**Re: Kirkpatrick  
8610 President Place  
Request Permanent C.O. - Accepted  
Engineer's Stamp dated: 2-5-15 (C17D122)  
Certification dated: 9-14-15**

**RE: Kirkpatrick Warehouse (File: C17D122)**  
**Grading and Drainage Plan, Engineer's Stamp Date 2-5-15**  
**Drainage Report, Engineer's Stamp dated 11-25-14**

**Re: Kirkpatrick Warehouse  
Kirkpatrick Warehouse Drainage Report with Engineer's Stamp dated 11-25-14  
Kirkpatrick Grading and Drainage Plan with Engineer's Stamp Dated 12-22-14  
(C17D122)**

**RE: Revised Grading Plan (C-17D122)  
Kirkpatrick Warehouse  
Albuquerque, New Mexico**

ENGINEER'S SEAL	TRACT B-1-A-5 CLIFFORD INDUSTRIAL PARK	DRAWN BY JDO
	GRADING AND DRAINAGE PLAN	DATE 01-12-2015
	1008 CENTRAL AVENUE SE SUITE 201 ALBUQUERQUE, NM 87106 (505) 871-8888	SHEET 1 OF 1
		JOB #

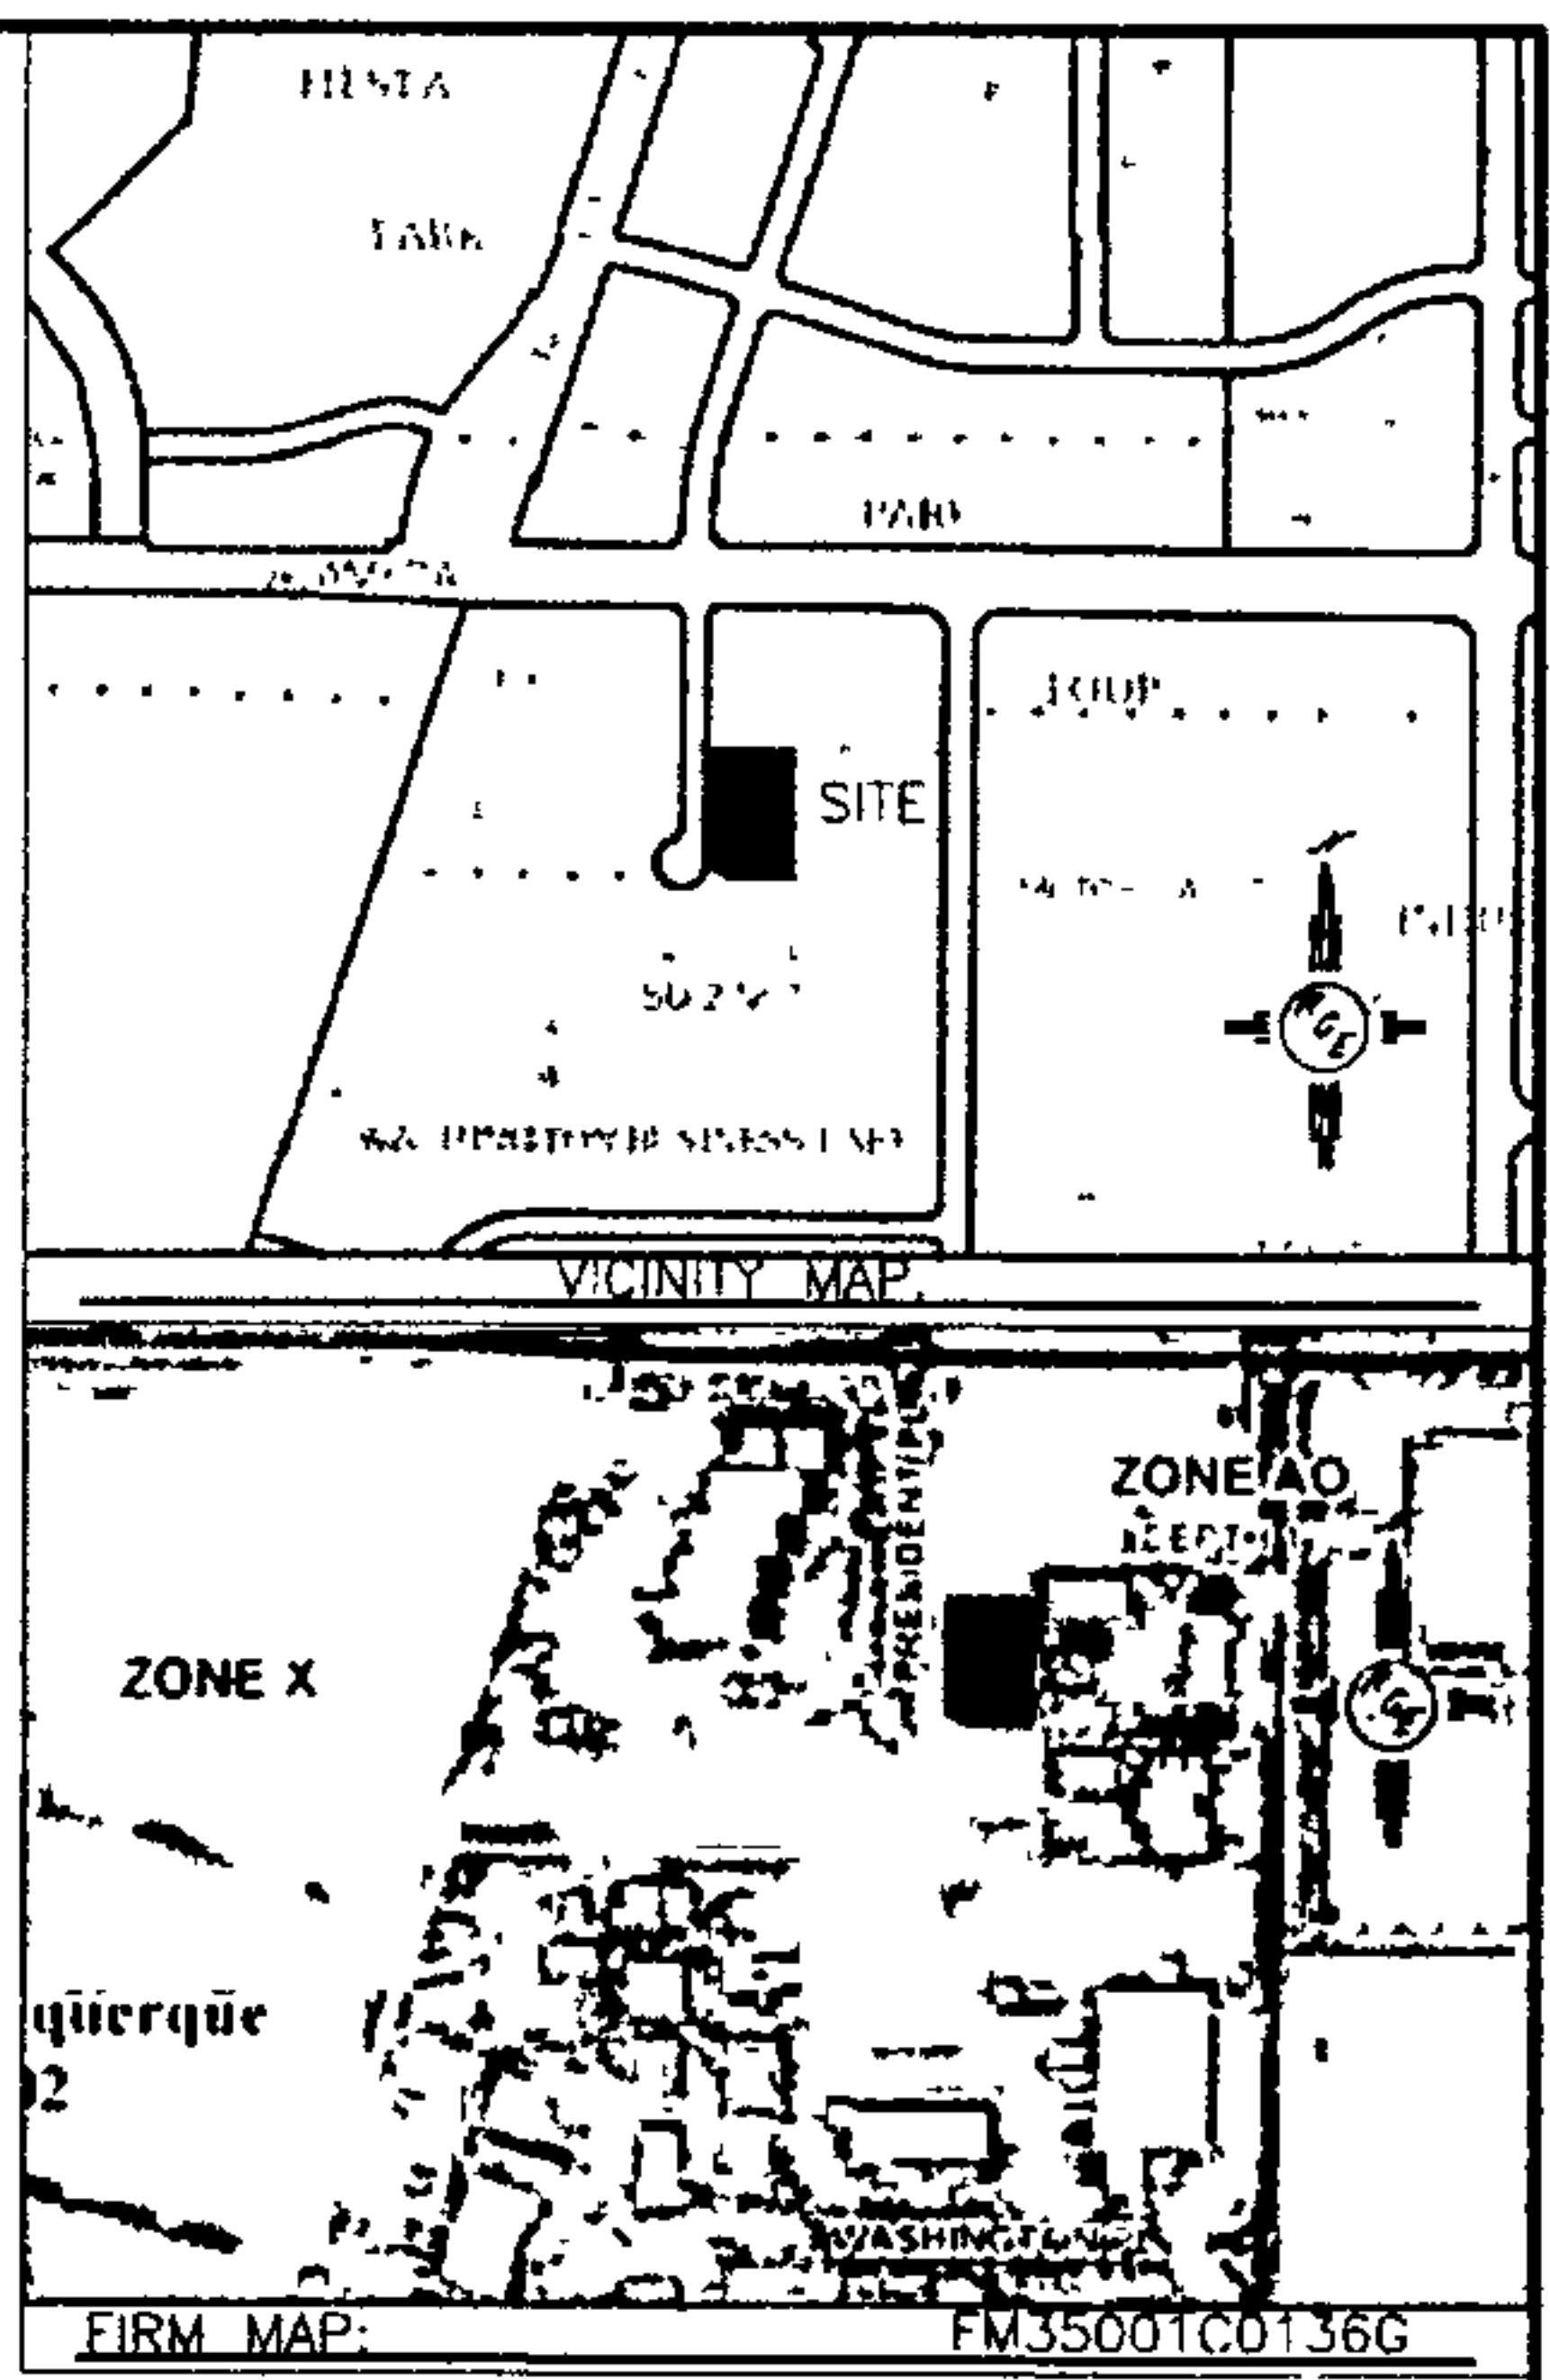
- Add rip-rap where the drainage channel along the south side discharges to the retention pond.
- Note that the fence is to be removed.
- Limit the diameter or size of any landscaping that is to be put within the channel so that the capacity of the channel is not reduced.

1. Lower the invert of the Stormtech chamber so it fits under the pavement.
2. Provide which foundation depth the contractor should be using.
3. Put the spots back on the valley gutter that were on the previous plans.

DC-780 ISOLATOR ROW DETAIL  
NTS

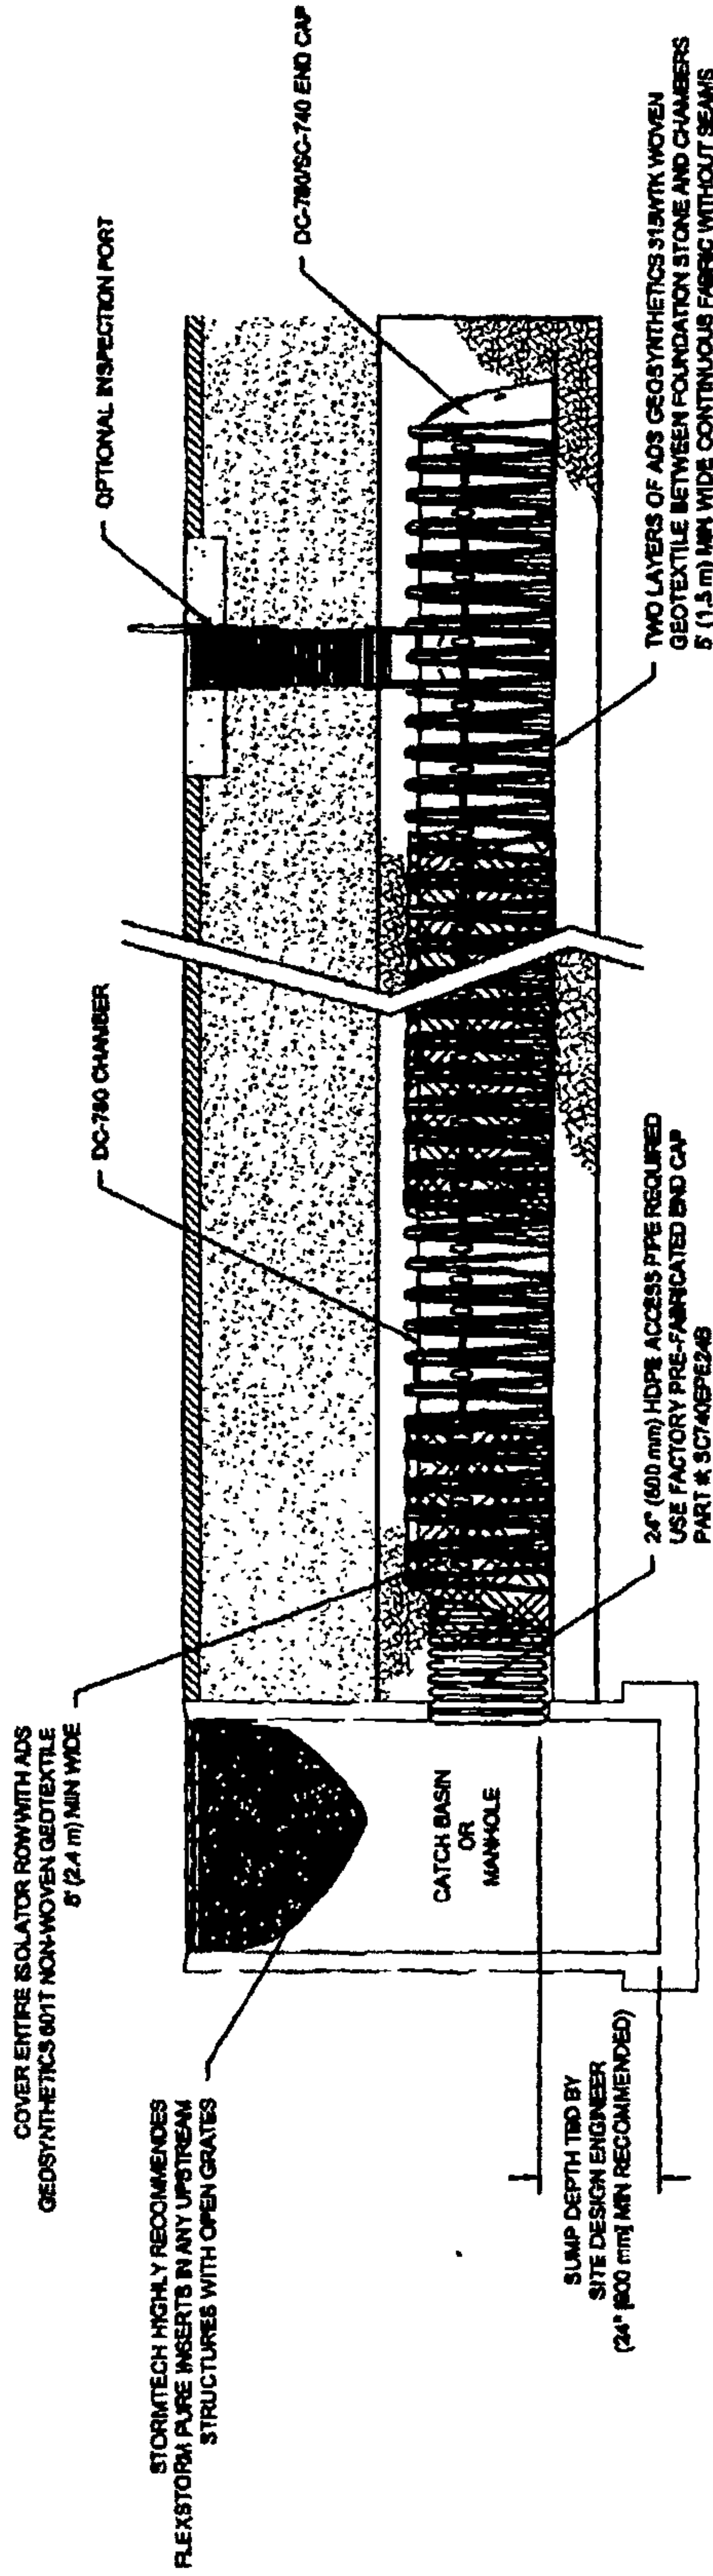
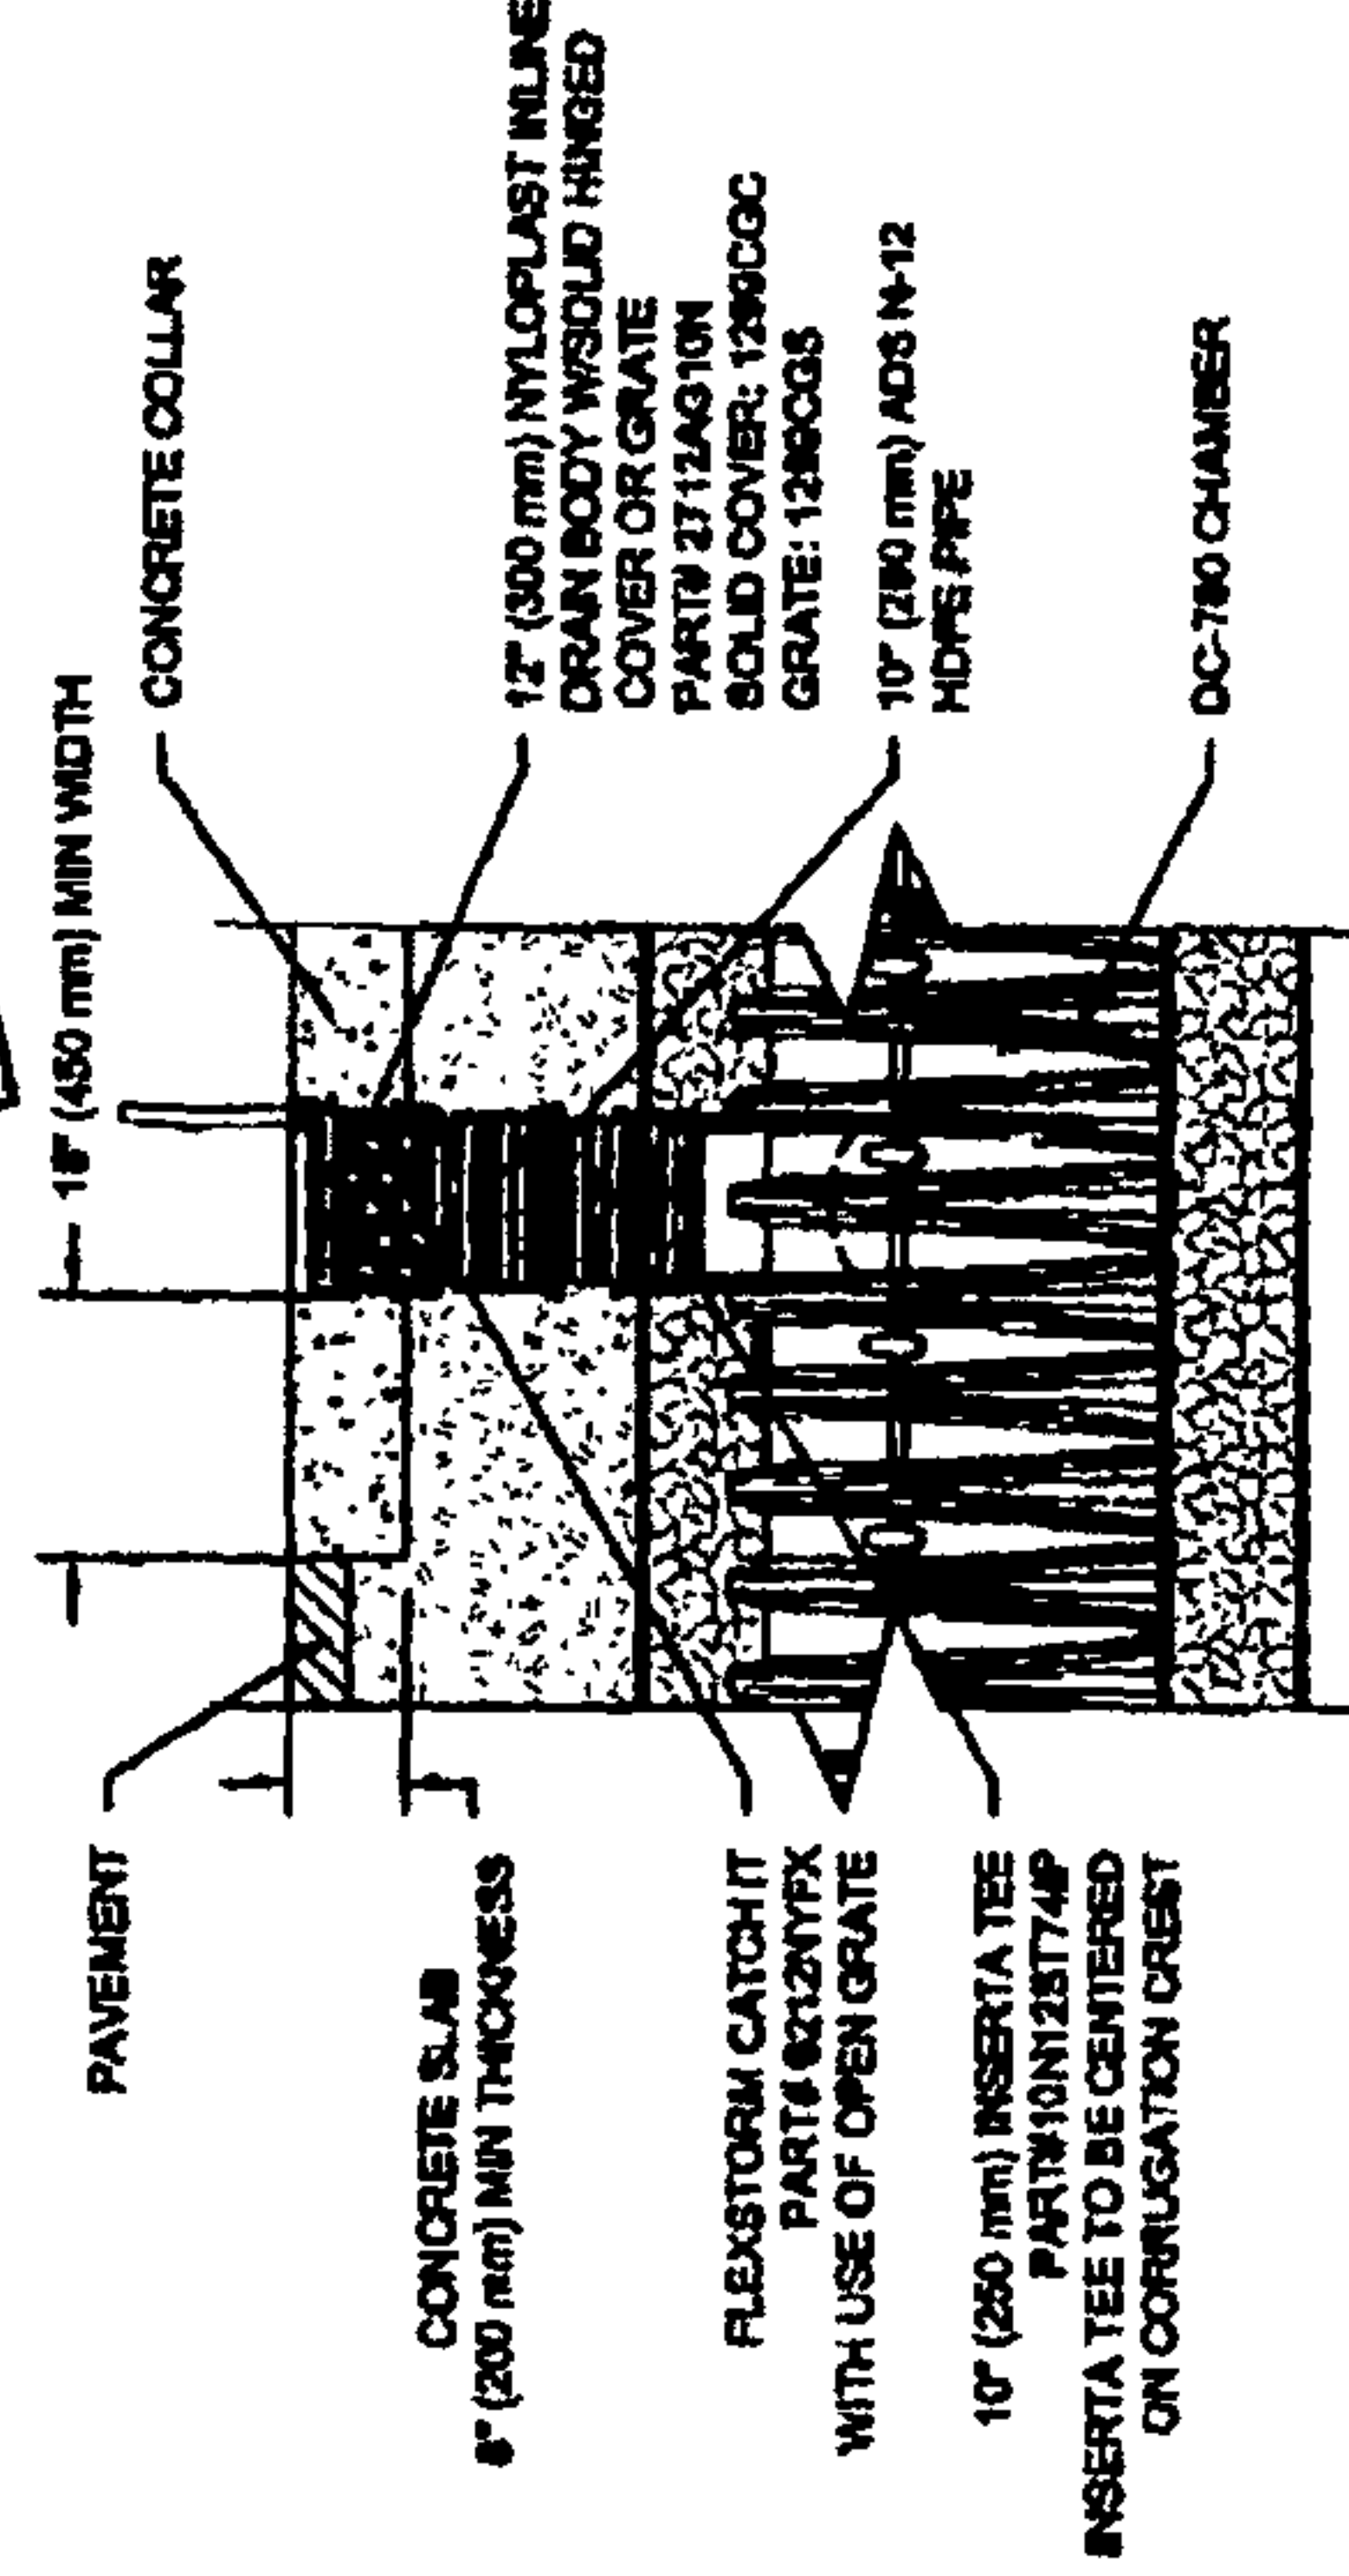
2. Provide detail sheets for the stormtech systems.

1. Include calculations for the design of the Stormtech system.
2. Provide a detail sheet for the Stormtech system that includes plan and profile views.
3. The inlet grate is at 94.25 but the invert is at 59.75. What should the invert really be at?
4. How will the manifold system be set up? How far apart are the rows? How will flows go into the isolator row? How will the isolator row be maintained and cleared of debris?
5. You have specified S780. Do you mean DC-780? What stub are you specifying?
6. What are the depths and type of stone for the whole system?
7. What kind of geotextile is being used? Where is the fabric located?

**We have added the individual details to a detail sheet**

2677/78.4 = 34 chambers
